Subject: RE: NYM/2023/0527, Burleigh Cottage, Brig Garth, Robin Hoods Bay

As you may be aware I spoke to Annabel 2 weeks ago regarding the Listed Building Application.

Ground Floor Plan (Florence Cottage)
 Scale 1:50

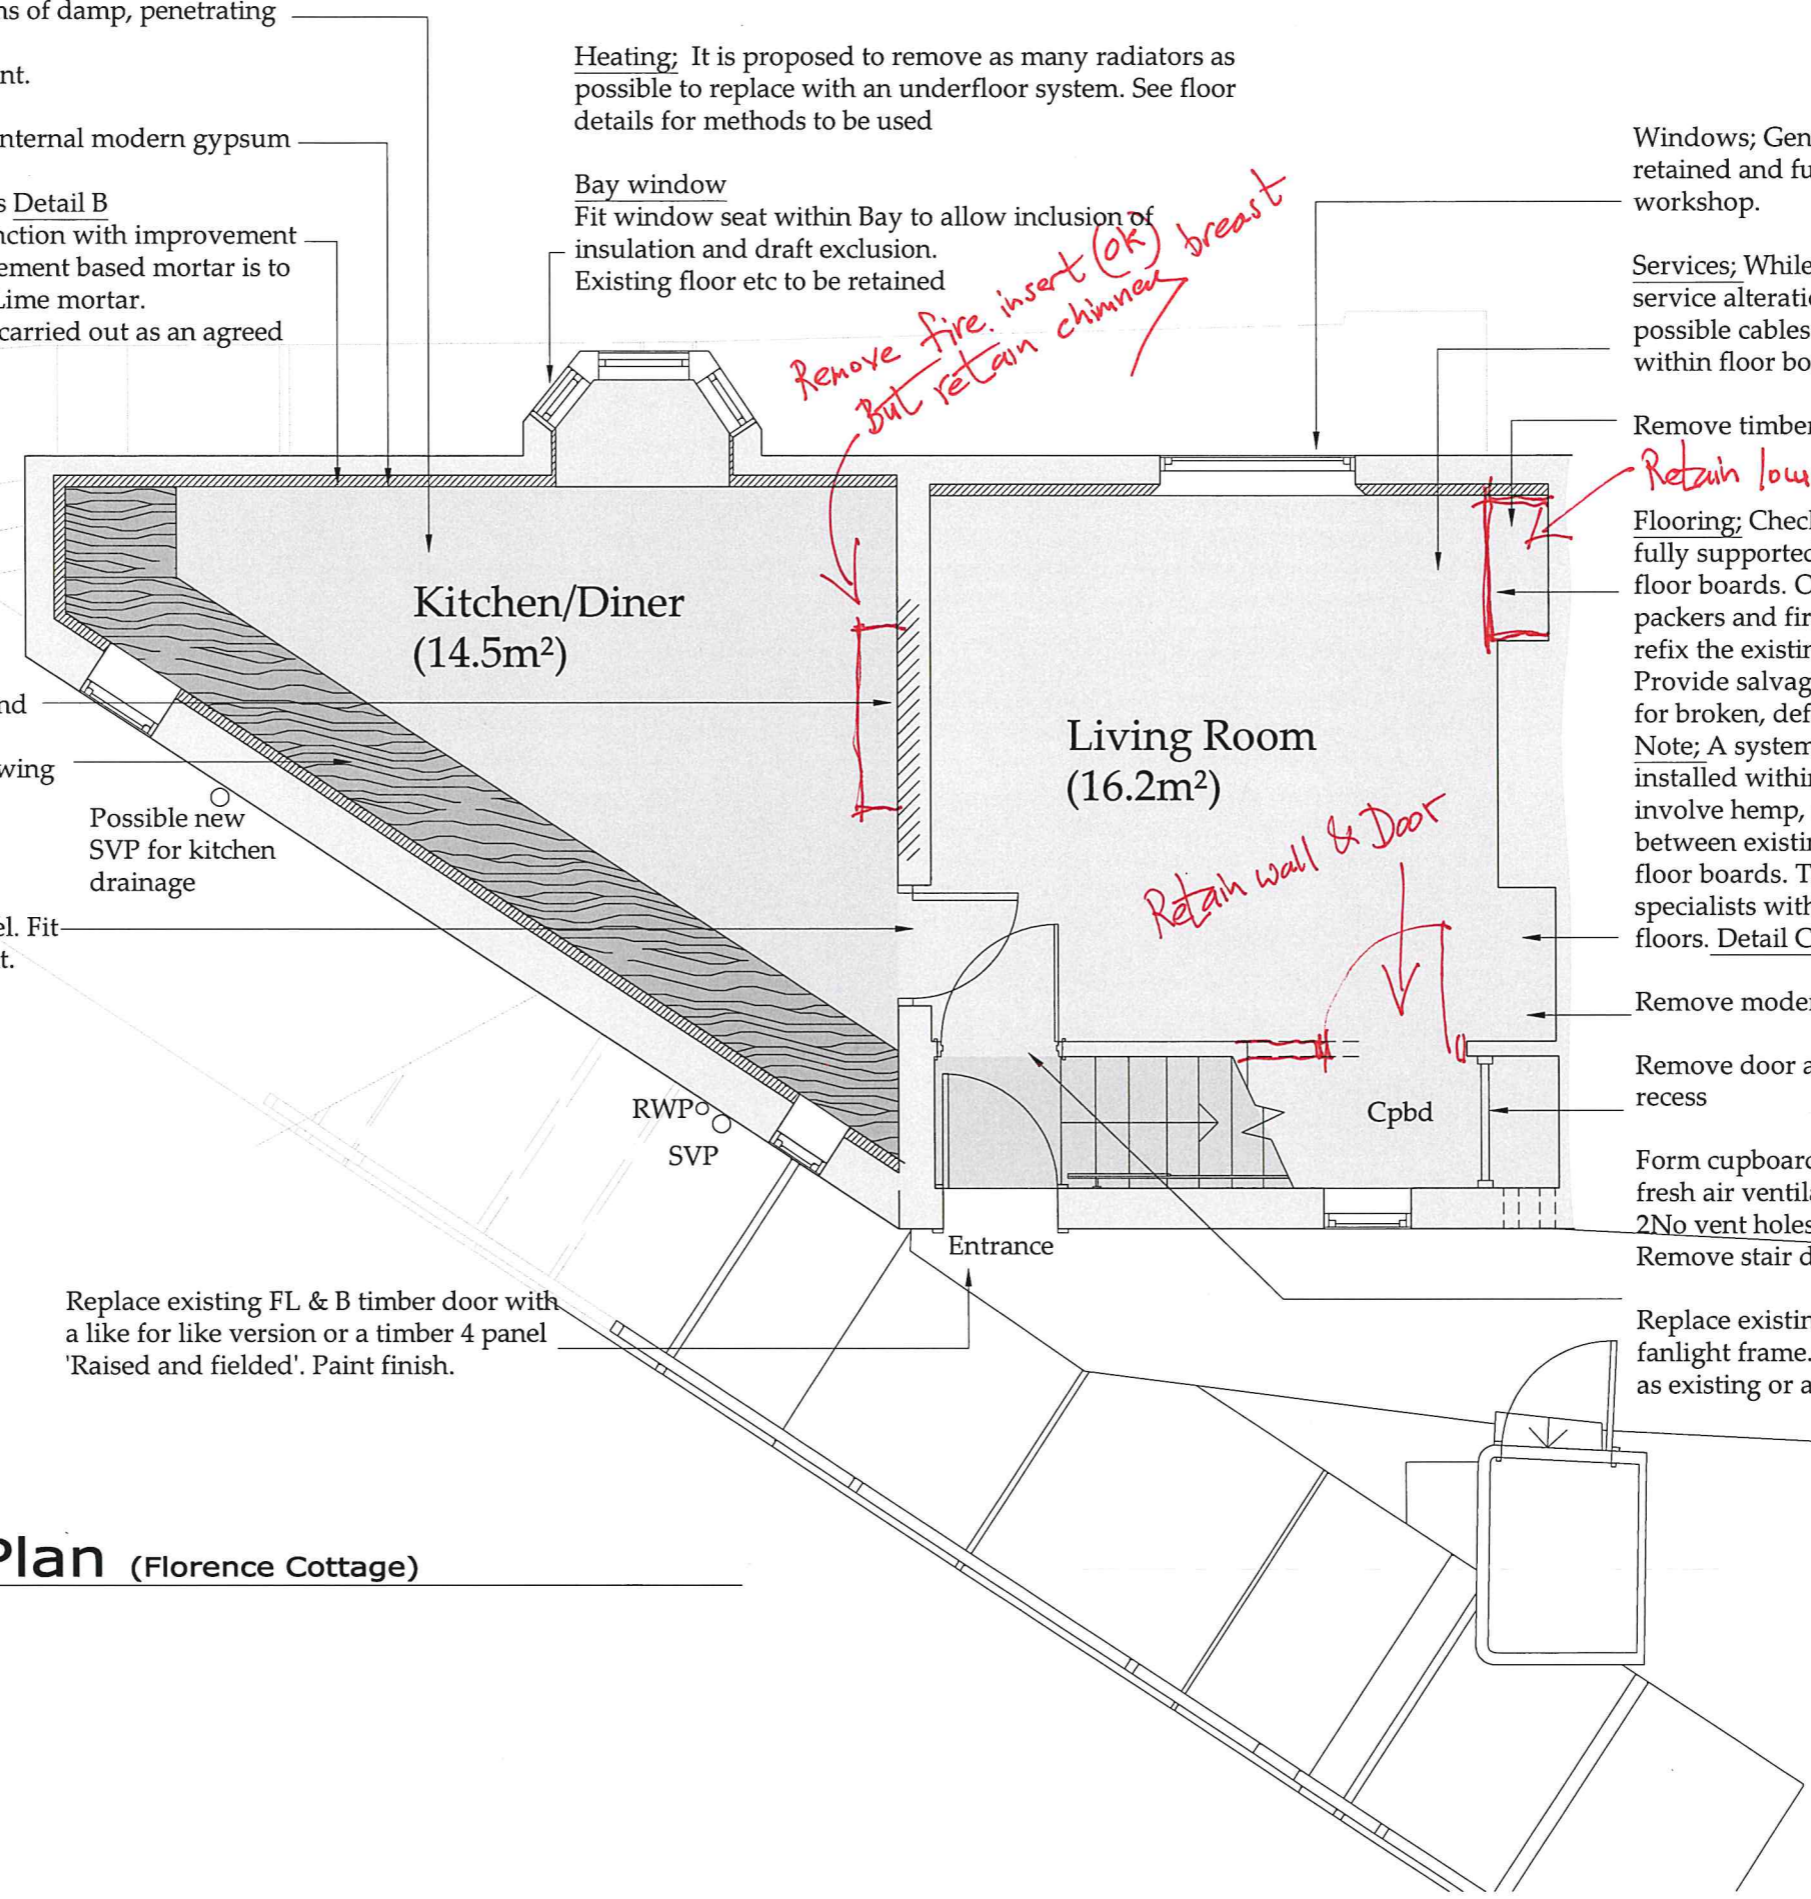
Another point was retention of something associated with the current modern stair up from the Lower Ground Floor.

I confirmed we would retain the Ground Floor wall and door which will form a cupboard to the rear of the Living Room instead of a stairwell. We trust that this satisfies the requirement for retention of historic features. It is agreed this is worthy of retention, but not that it previously housed a more original Stair. It really is not possible as noted and I believe agreed in our previous email dated 25/01/24.

Other retained features as requested by Annabelle will be the low level cupboard adjacent between the chimney breast and external front wall and the chimney breast on the cross wall. All on the Ground floor.

Remove fire insert (ok) but retain chimney breast

Remove timber shelves.
Retain low level cupboard.

Form cupboard to house duct to incorporate fresh air ventilation system.
 2No vent holes in external wall
 Remove stair down to Lower ground

Retain wall & Door
